This Service Information bulletin supersedes SI 11 23 14 **dated January 2015**.

Service Action: Replace the Thermostat (F10)

F10 (5 Series Sedan)

With the N20 engine

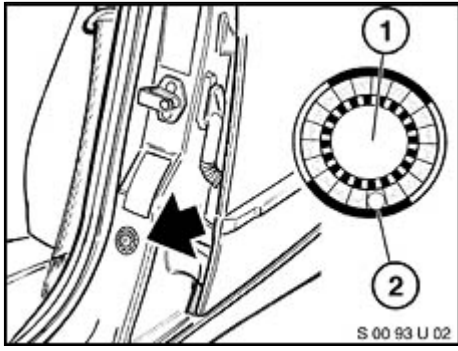
The Service Engine Soon light is on with corresponding fault codes in the DME for the engine thermostat.

Moisture and corrosion could develop on the electrical contacts for the heater circuit in the thermostat.

Replace the engine thermostat. Follow Repair Instruction RS 11 53 000, "Removing and installing/replacing coolant thermostat (N20, N26)."

P/N 11 53 8 648 791, as specified and listed in this Service Information bulletin below, must be ordered and installed for this Service Action.
